ADDENDUM NO. 01
April 5, 2024

DISTRICT-WIDE ACCESS CONTROL UPGRADES
PACKAGE 2
CLOVIS UNIFIED SCHOOL DISTRICT

2-CEH-AC16

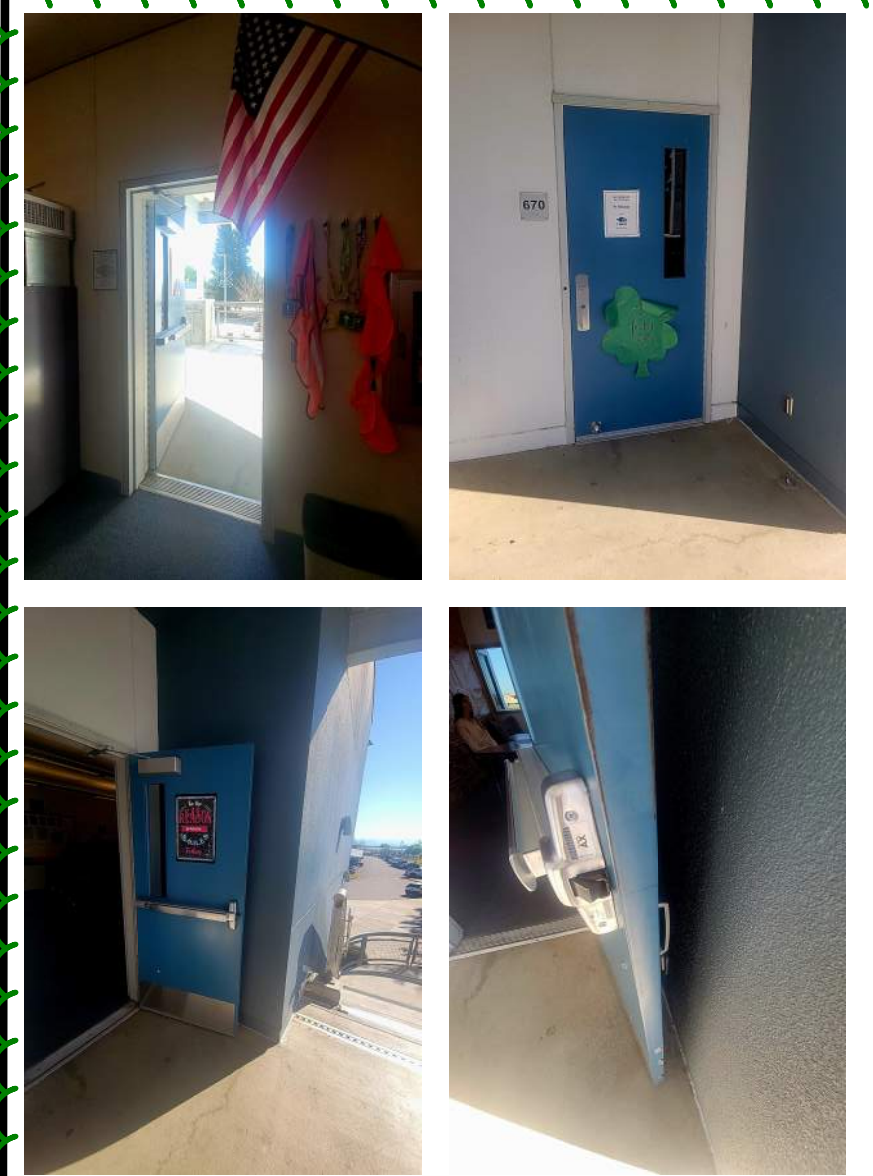
- Item No 01** **Sheet 2-CEH-AC16 – Clovis East HS – Classroom 600 – First Floor**
 - a. Added photos of Classroom Door 08.
 - b. Update door hardware to include armored loop in lieu of electric hinge
- Item No 02** **Sheet 2-CEH-AC35 – Clovis East HS – West Gym**
 - a. Added card reader and identified weight room door on plan. Photos already shown on door photo sheets.
- Item No 03** **Sheet 2-FCC-AC5 – Fancher Creek Elementary – Library**
 - a. Removed library classroom door from needing card reader. Remove reference to reader, door hardware and associated cabling.
- Item No 04** **Sheet 2-FCC-AC6 – Fancher Creek Elementary – Library Photos**
 - a. Removed photos of library classroom door.

CHANGE TO DOOR CORD WITH 626 FINISH DUE TO CONTINUOUS HINGE CONFIGURATION

2-ORZ-AC2

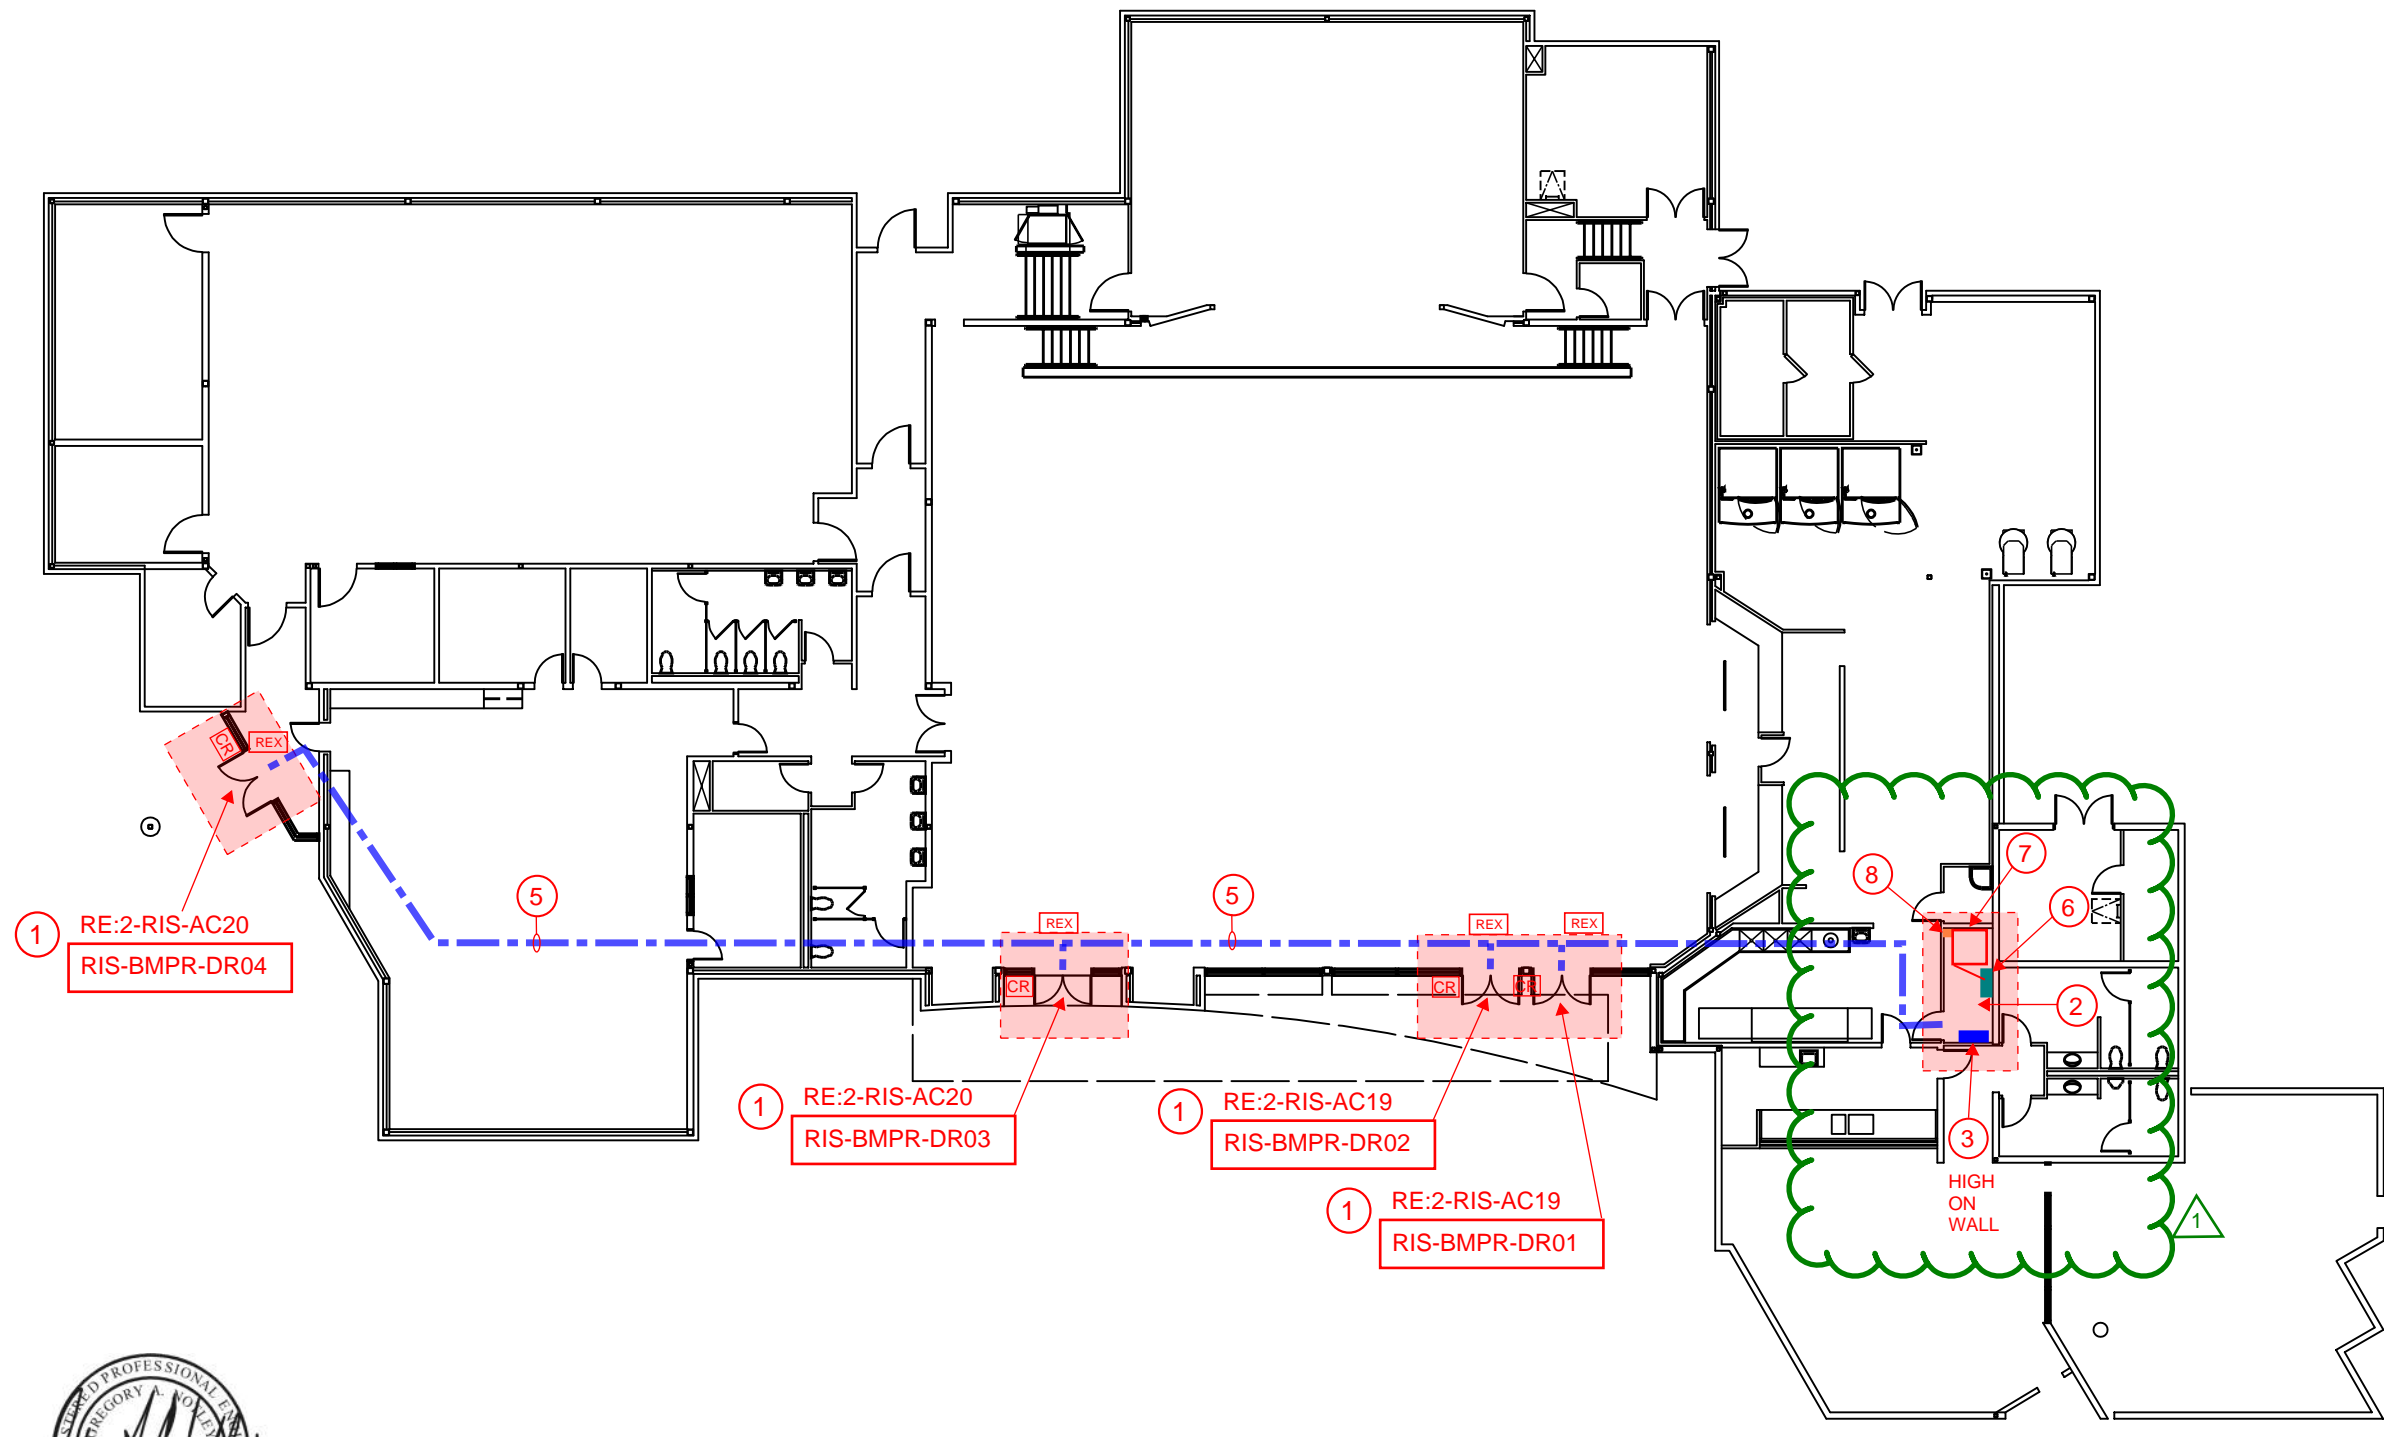
- Item No 06** **Sheet 2-FCC-AC10 – Fancher Creek Elementary – MPR Photos**
a. Removed photos of Door 05 at MPR.
- Item No 07** **Sheet 2-ORZ-AC2 – Oraze Elementary – Administration**

a. Modified routing of homerun cabling from door readers back to main access control panel to reduce the amount of surface mounted raceway needed for cabling installation.

2-RIS-AC18

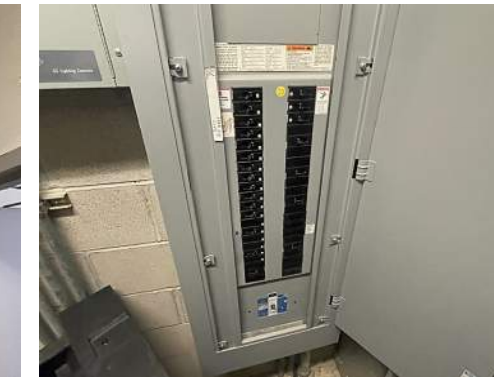
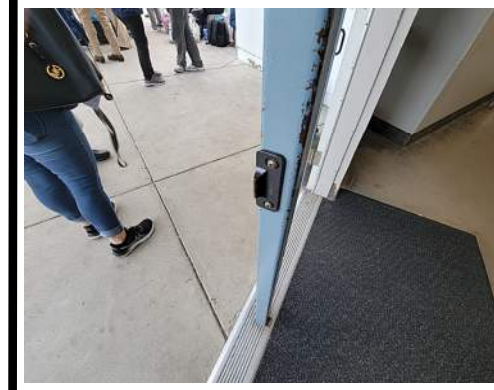
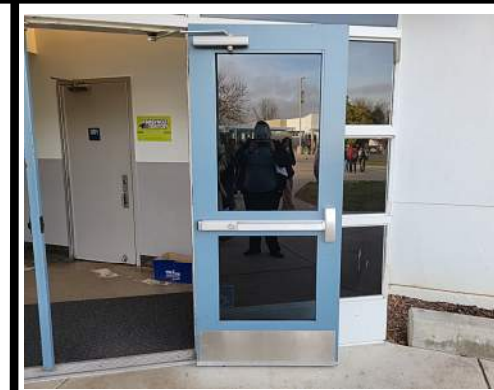
- Item No 08** **Sheet 2-RIS-AC18 – Reyburn Intermediate - MPR**
a. Updated IDF layout for existing network rack location.
- Item No 09** **Sheet 2-RIS-AC20 – Reyburn Intermediate - MPR Photos**

2-RIS-AC20

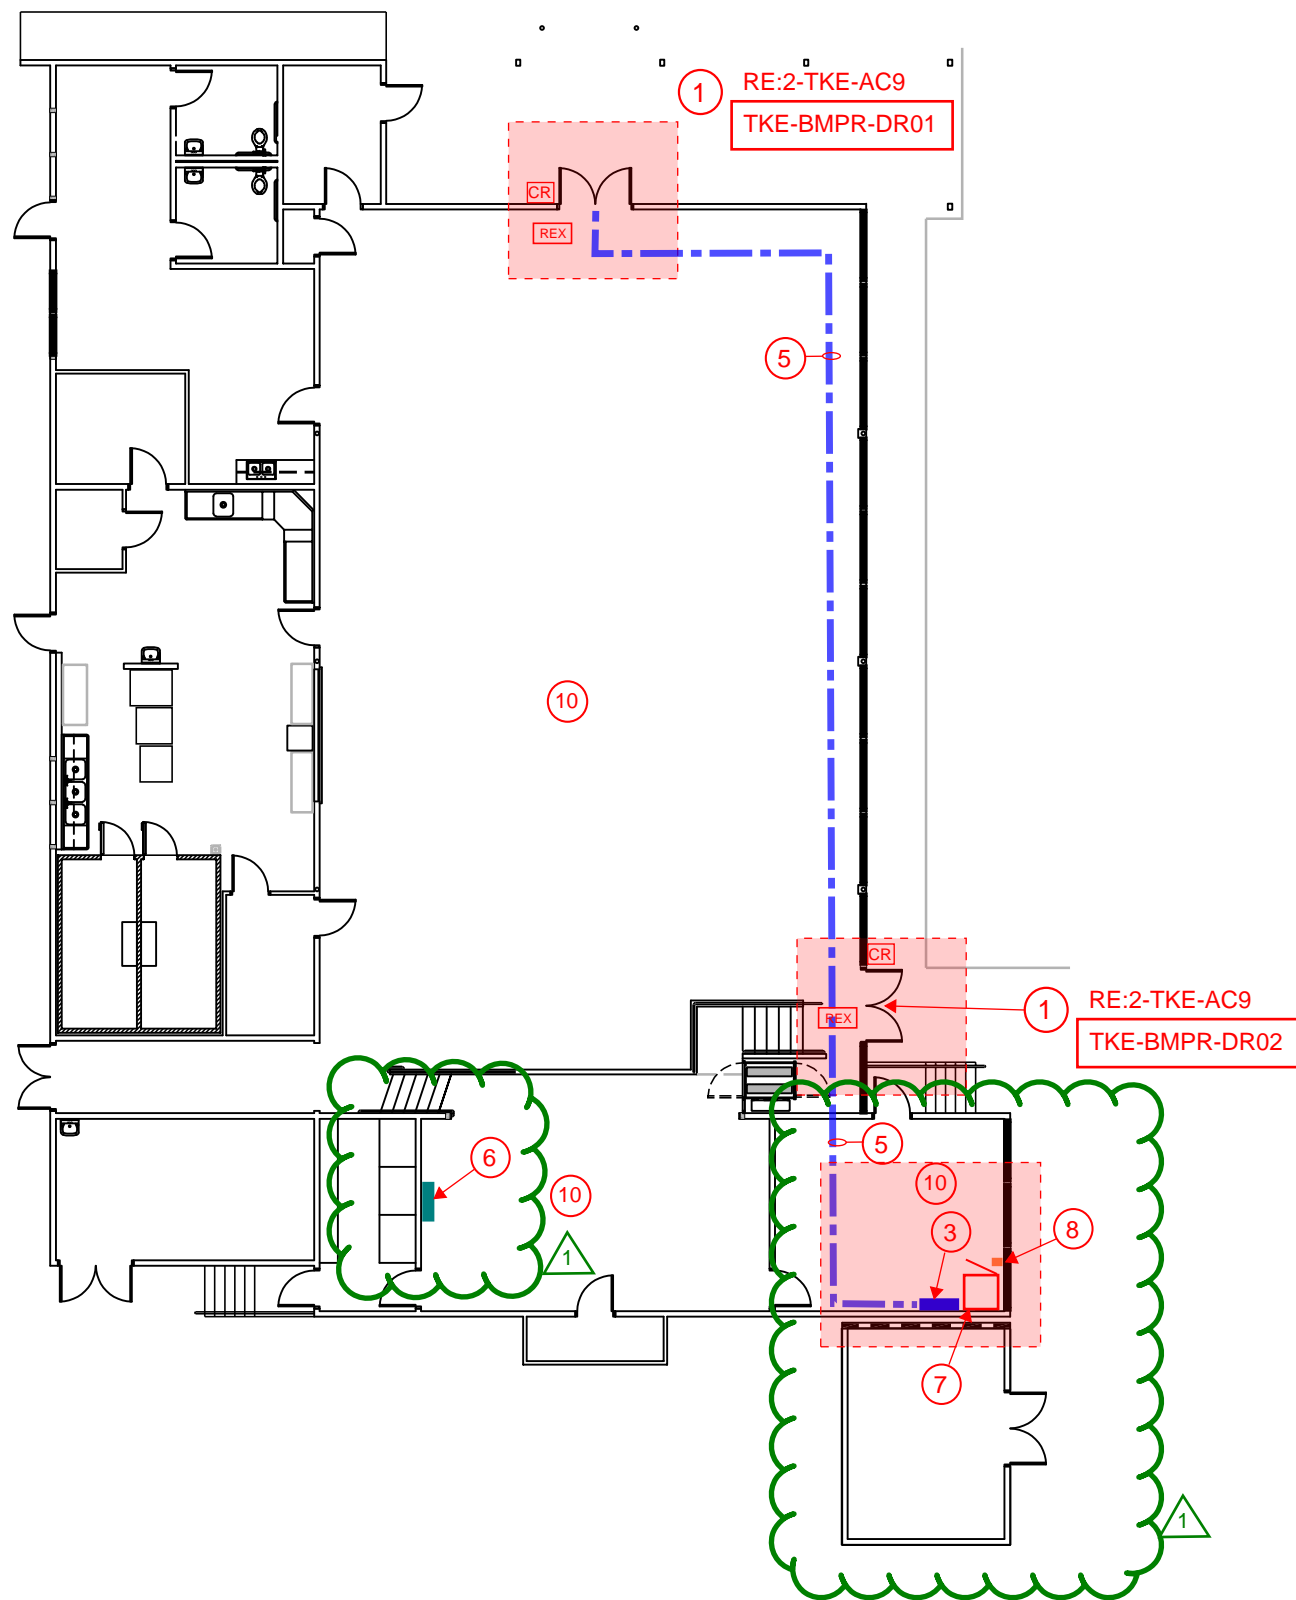
a. Updated photos of existing telecom / electrical room in MPR Building
- Item No 10** **Sheet 2-TKE-AC8 – Temperance Kutner Elem - MPR**
a. Updated location of existing network rack and new access control panel.
